To
Subject Evaluation at CRS

EPA Region 5 Records Ctr.

CRS diagram.pdf

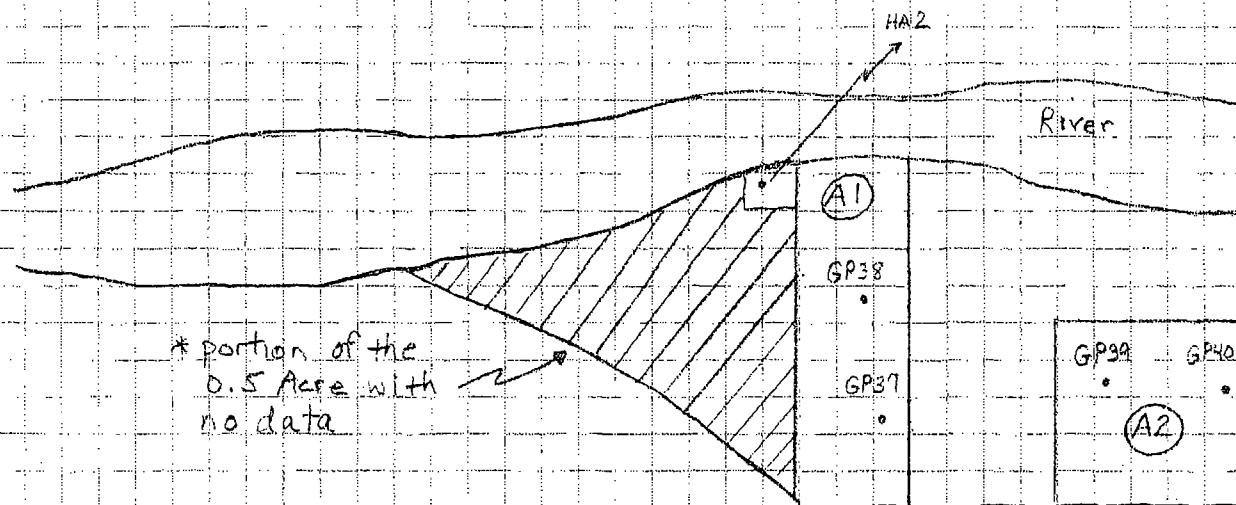
If you look at remaining concentrations of TCE above the RAO, it's actually limited to 5 locations at the 0 - 4 ft. depth range. Those are HA-2, GP38, GP37, GP39, and GP40.

I've attached a diagram in PDF of a sketch for your consideration. I've carved out 2 main areas targeted for excavation which are designated as A1, and A2. The rest of the area already meets the RAO, and would EPA consider limited excavation or perhaps none at all in those specific areas? Please keep in mind this is only a rough idea, and a thought !

The main question I have for you good folks is the hashed area on the diagram. Will excavation be required in the south half of the 0.5 acre. I think it would be difficult to negotiate or justify a 4 ft. dig in this area due to a lack of data supporting the need for that. Will the Agency ask for sampling in this area, or can we live with the information that we have?

In any case, area A1 is approximately 30' x 95', and A2 is approximately 50'x50'. At a 4 ft. depth of excavation, the math is easy to do for estimating the volume of soil to be removed.
